CONSERVATION COMMISSION AGENDA

The Conservation Commission will hold this meeting as a virtual meeting on Thursday, April 1, 2021 at 7:00 pm. No in-person meeting will take place at City Hall.

Enhancement Planting Area (450± sf)

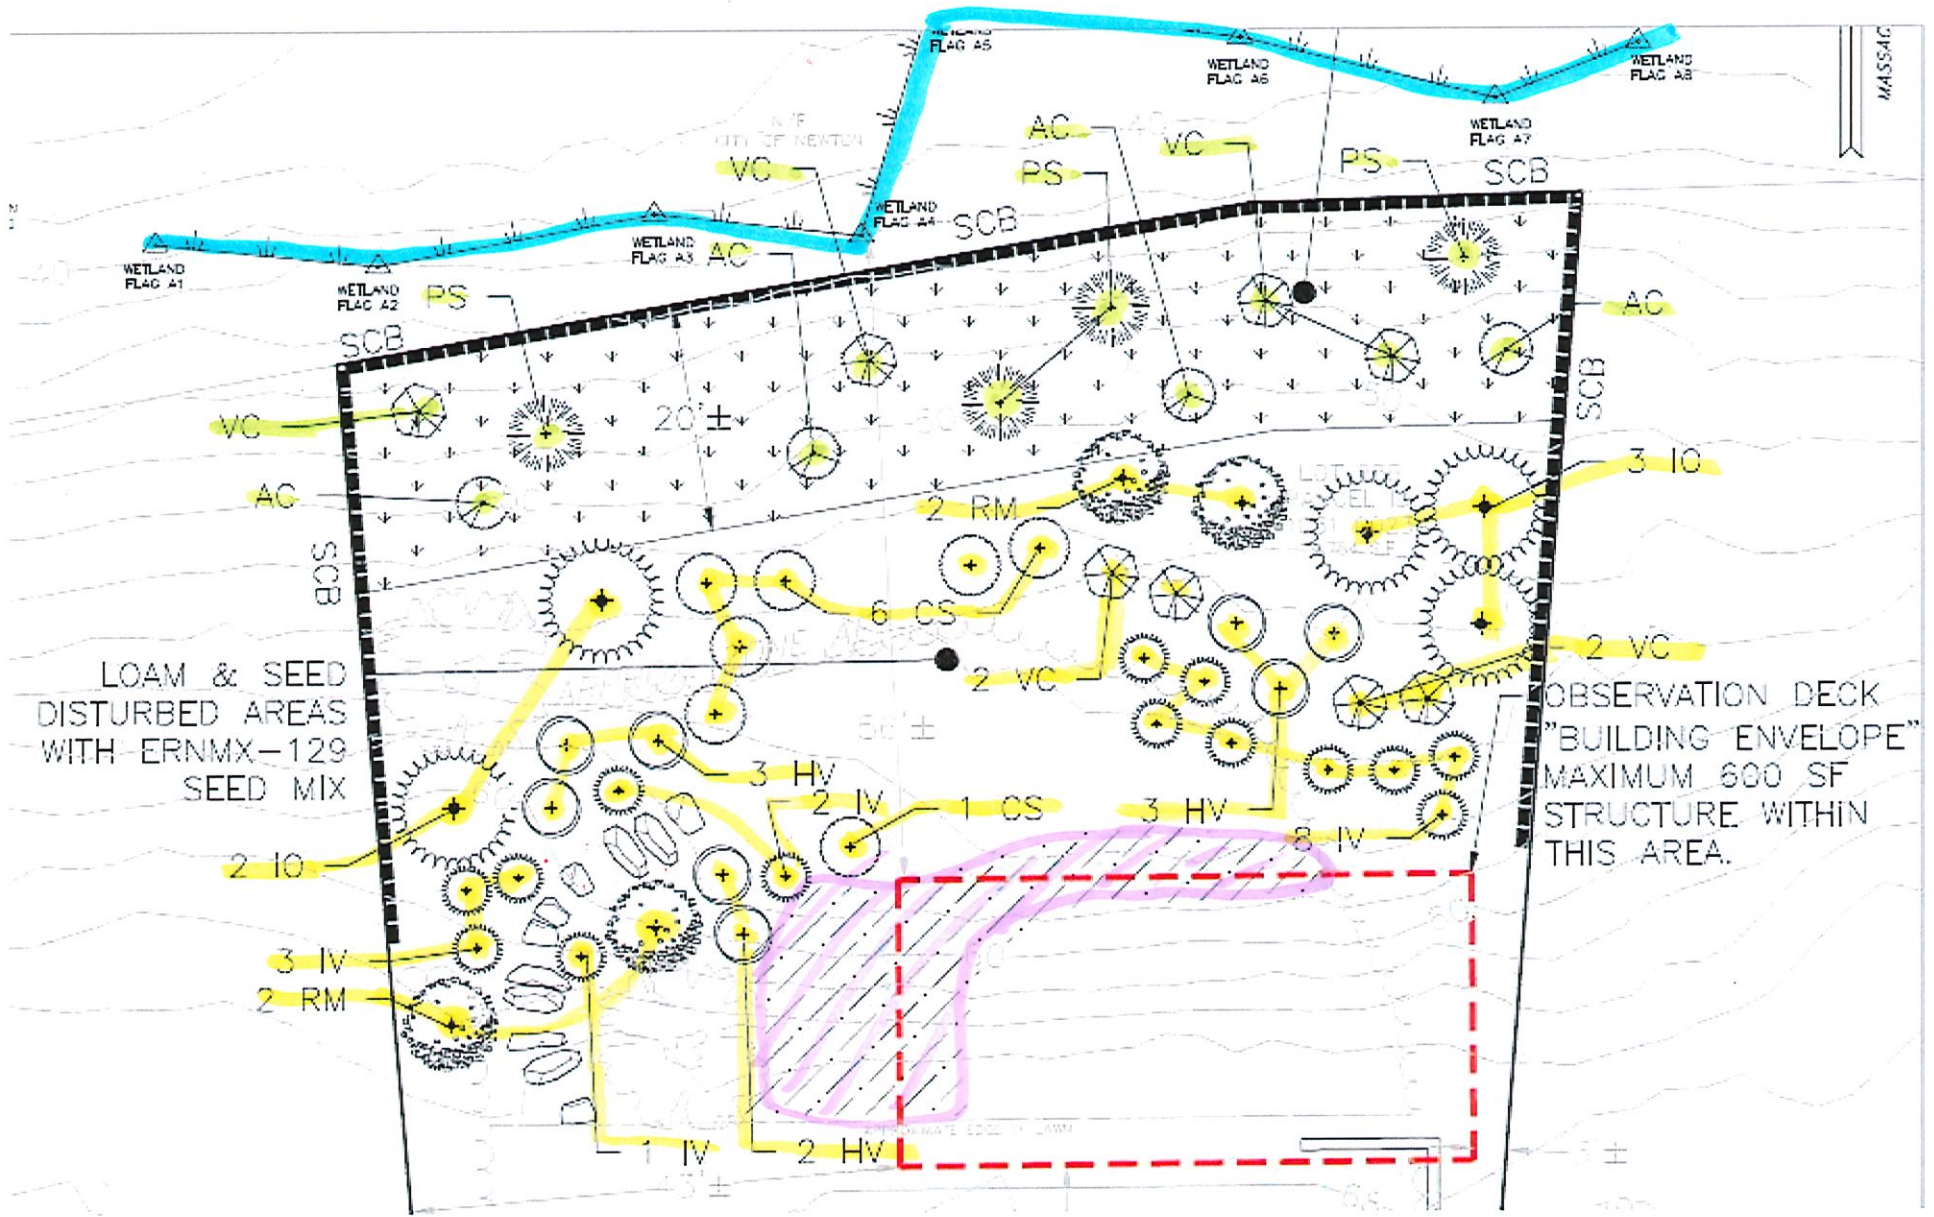
- Staff Notes:
 - Applicant should clarify whether the driveway is proposed to be expanded. The stippling and striping on the plans make the intended finished condition unclear.

- The Commission should determine whether the removal of the 43" tree must be addressed by the applicant.
 - Since 3 hemlocks with a sizable footprint are already where the mitigation area is proposed, the mitigation planting area should be expanded so that new mitigation of over 340 sf is provided.

- No tree protection is proposed for the existing hemlocks to be included in the mitigation planting area. Staff recommend requiring that the mitigation plantings be installed, the area bounded, and then additional fencing installed around it prior to other work starting on site.

- Tree protection consisting of orange, snow fence installed at the drip line of the tree must be installed on all trees proposed to remain.
 - Approved, native mitigation plantings must survive at XX% after 2 growing seasons.

**NOTE
PREVIOUSLY APPROVED
DESIGN SHOWN IN RED**

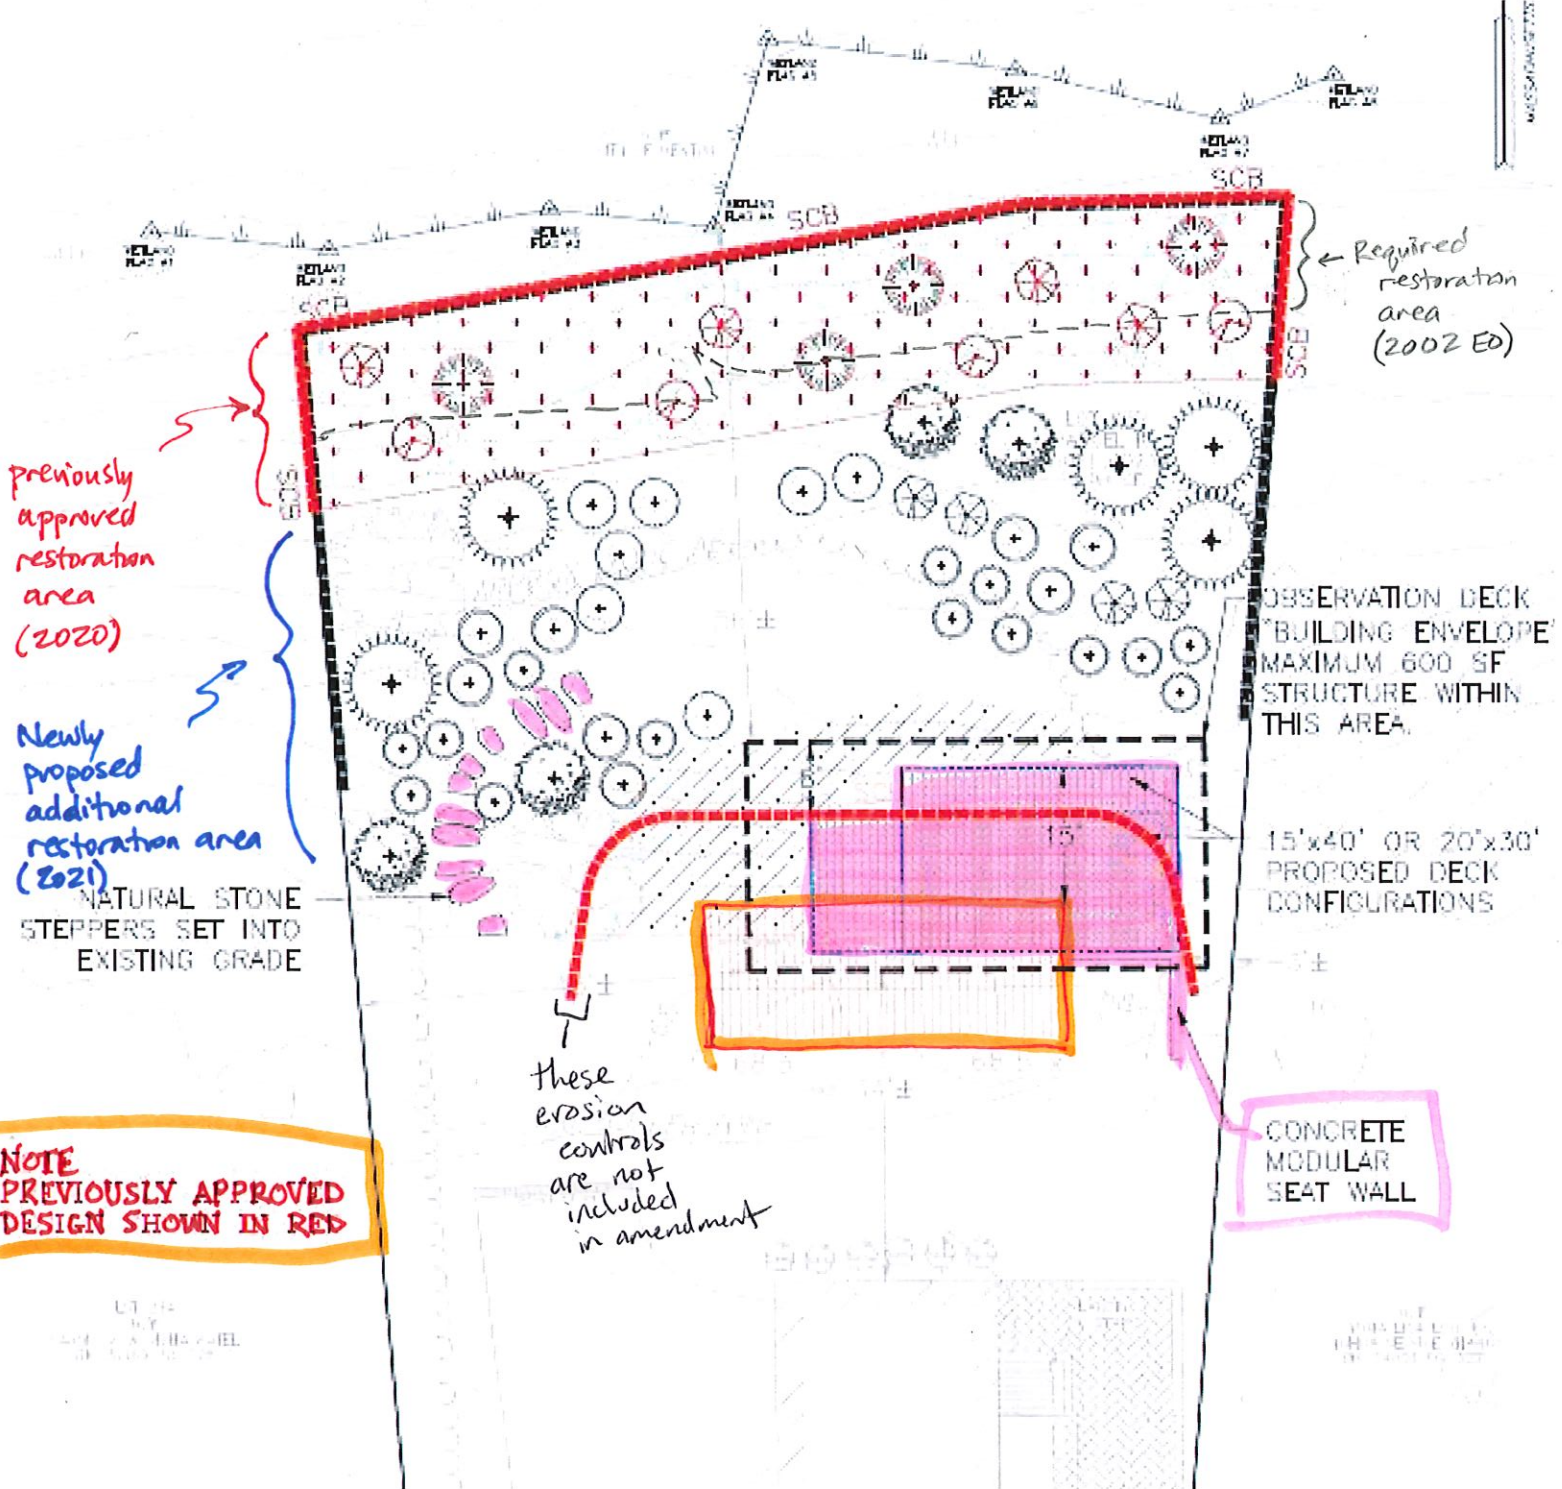
- All invasive species removal approved is still proposed.
 - Staff Notes:
 - The original intention of the project is the same, but corrected field measurements showed that the approved deck location would be further within existing lawn than the owner intended. The revised location shifts the deck further over slope.

- The proposed change in deck location will result in minimal increased disturbance of very degraded buffer zone.
 - The proposed additional plantings seem appropriate mitigation for the additional disturbance proposed by the shifted deck location and new stairs.

- Staff note that witch hazel can be difficult to find in local nurseries.
 - Slope restoration will require the removal of Norway maple saplings and other invasive species. It may also require soil augmentation to facilitate tree and shrub survival. It will also entail “loam and seed” and staked fabric as noted in the slope stabilization detail. The applicant should be provided permission to do what it takes to ensure a successful restoration project.

- **Slope restoration must be executed as per the approved plans. If necessary/desired, organic leaf litter mulch may be applied around approved plantings to minimize competition from weed and invasive species.**

- Landscape plantings within Commission jurisdiction must:
 - a. Be installed in compliance with the **revised plans dated _____** (desired changes must be approved by the Conservation office in advance).

Approved "Consolidated" Plan Excerpt Showing the Trees in Question

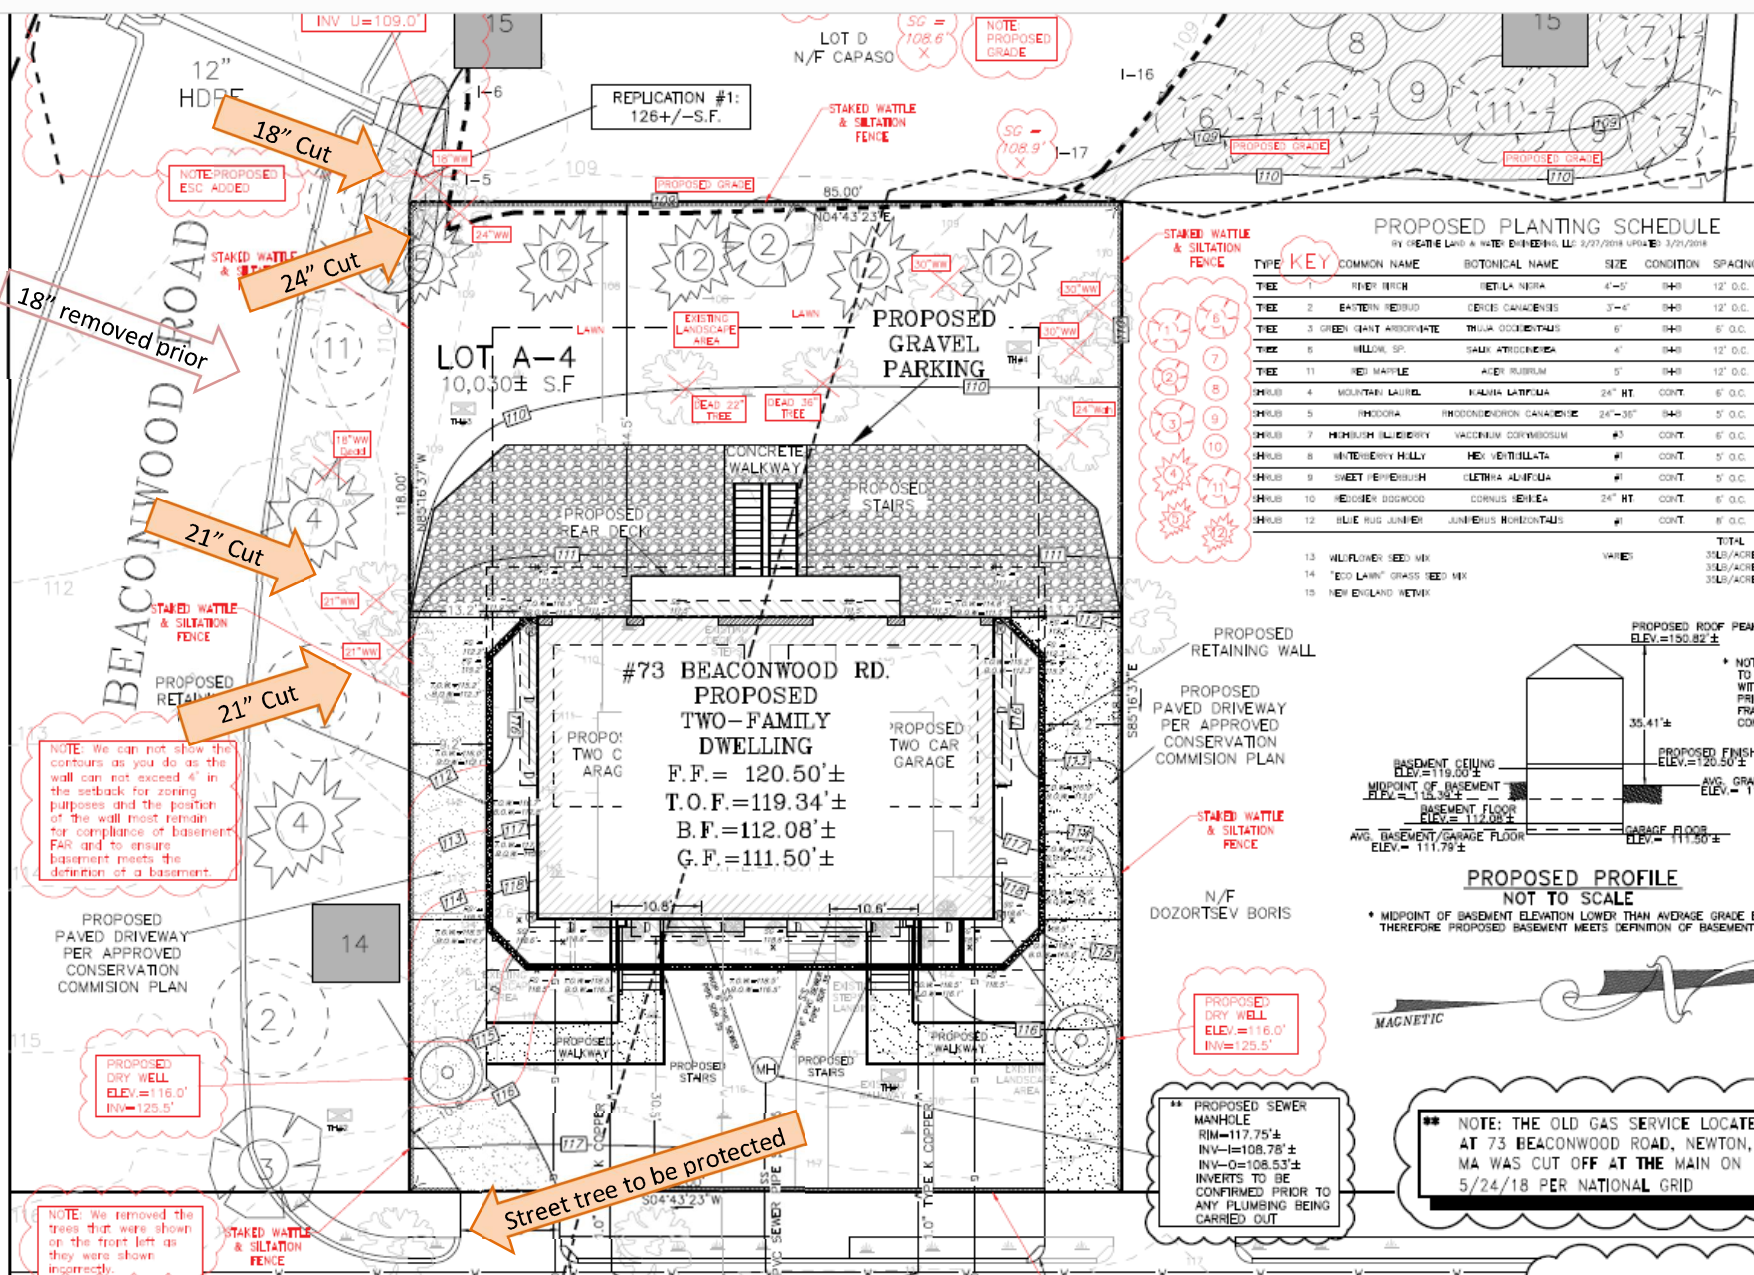
- Note: A stop work order was issued for this lot by the Inspectional Services Department at this time as well.
 - On March 24, 2021, the Conservation Office received a phone call about tree cutting on site. A site visit revealed tree cutting had occurred and clean-up was continuing. Said tree cutting was within the 100-foot buffer zone line, said work was predominantly on 77 Beaconwood Road, and the street tree shown on the approved plans as to be protected lacked any protection. At this time:

- Install tree protection on the street tree.
 - Request permission in writing of Mr. Capasso to install restoration plantings in the area of the violation (which falls on 77 Beaconwood), as shown on the approved plans, on or before June 15, 2021, with the Conservation Commission cc'd on said request. Said restoration shall be installed on or before June 15, 2021 if Mr. Capasso grants permission to do so, otherwise, said restoration shall occur prior to the expiration of the OOC.

23. Protection of tree: The one tree marked for protection on the approved plans must be protected before and during construction activities with orange snow fence installed at the dripline of the canopy. If it dies within 2 years of the start of construction or has been demonstrably harmed by construction activities, it shall be replaced with 2 native canopy saplings (of roughly 2 caliper inches).
